Subject File: BRAKES

Subject: Remove Check Valve Components from Meritor Wabco Pressure Protection Valve (PPV) used in conjunction with the System Saver 1200 Air Dryer

Expense is to be charged to Warranty. Claims are to be submitted in the normal manner, making reference to Authorized Field Change Number G-06910.

Figure 1 Air Dryer

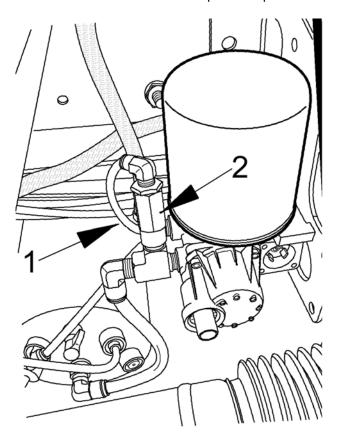
The Meritor Wabco System Saver 1200 with a pressure protection valve (PPV) does not allow enough air volume to effectively purge the dryer desiccant cartridge during the purge cycle. (*Note that suspect units are VIN specific. Not all units in the date range are involved.)

- 1. Drain the supply (wet tank) and secondary air tanks until all the air has escaped from all drain valves.
- 2. Remove the air line and the pressure protection check valve from the air dryer (Figure 1).

- 1. Air Line
- 2. Pressure Protection Check Valve
- 3. Remove check valve parts from the valve (Figure 2) by removing the snap ring.
